Work Order ID 101166

Item Name: Crosstube Turning Detail

DART AEROSPACE LTD		Work Order:	101166
Description: Crosstube Assembly		Part Number:	D407-667-145
Inspection Dwg: D407-667-145 Rev: C		Page 1 of 2

DRAWING NO. D407-667-145	TITLE CROSSTUBE ASS'Y (407 HIGH FWD)	REV. C	DART AEROSPACE LTD ENGINEERING ORDER		D.E.O. NO. D407-667-145-C-1	SHEET NO. SHEET 1 OF 1	SCALE NTS
DRAWN 47	CHECKED ASS	MFG. APPR. 188	APPROVED MD		DE APPR. H		
DATE 11.07.15	DATE 11.07.22	DATE 11.07.22	DATE 11/07/22		DATE 11.07.21

DETAIL P
BONDING STRAP INSTALLATION 2 PL

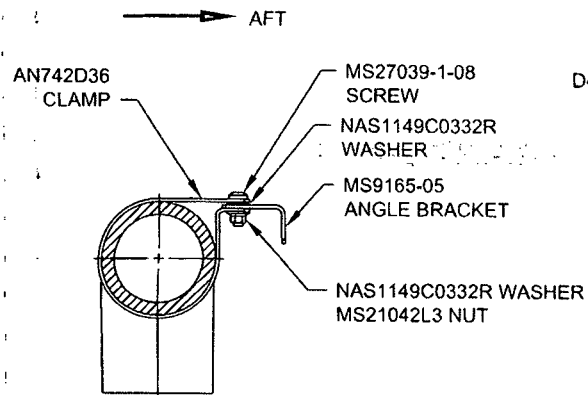
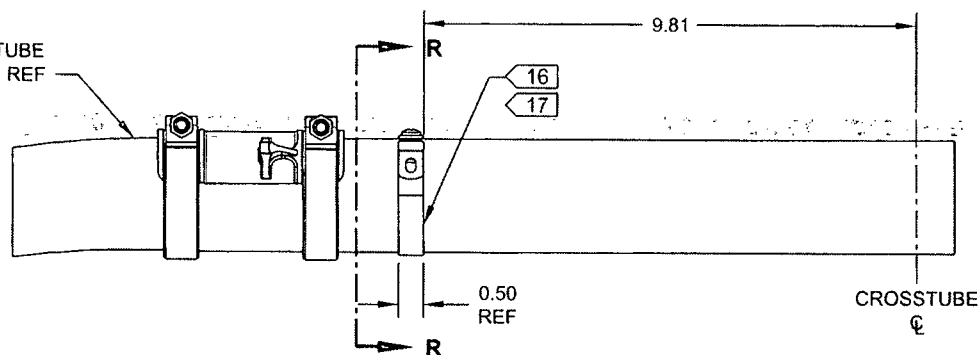
ADD ELECTRICAL GROUNDING STRAP

ITEM	QTY	PART NUMBER	DESCRIPTION
1	X	D407-667-145	CROSSTUBE ASSEMBLY (407 HIGH FWD)
10	2	AN742D36	CLAMP
11	2	MS9165-05	ANGLE BRACKET
12	2	MS21042L3	NUT (OR MS21042-3)
13	2	MS27039-1-08	SCREW
14	4	NAS1149C0332R	WASHER (OR AN960C10L)

- 16) MASK AREA UNDER CLAMP PRIOR TO PAINTING
- 17) SEAL EDGES WHERE AN742D36 CLAMP MEETS WITH THE CROSSTUBE USING SIKAFLEX-241/-291 OR MIL-S-8802 CLASS B2 OR PROSEAL 890 SEALANT
- 18) PERFORM RESISTANCE CHECK TO ENSURE MAX RESISTANCE IS 10 MILLIOHMS
